MIL-S-19500/496A(USAF)
AMENDMENT 2
21 June 1996
SUPERSEDING
AMENDMENT 1
29 October 1995

SEMICONDUCTOR DEVICE, UNITIZED, DUAL-TRANSISTOR, PNP, SILICON, TYPES 2N5795, 2N5796, AND 2N5796U, JANTX AND JANTXV

FIGURE 3. Physical Dimensions, 2N5796U."

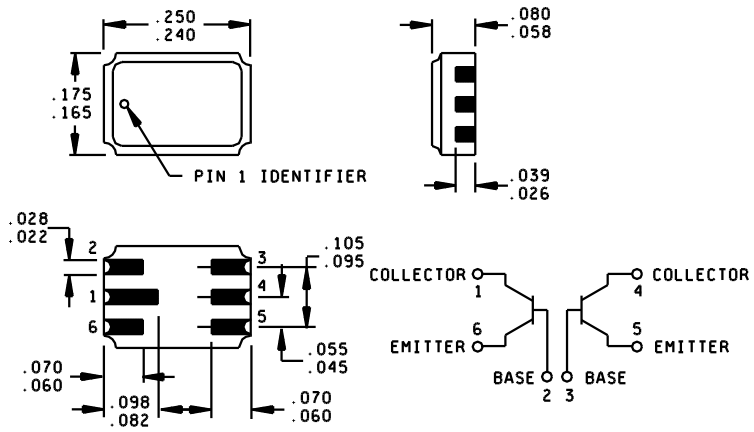
* FIGURE 3, delete and substitute as follows:
"
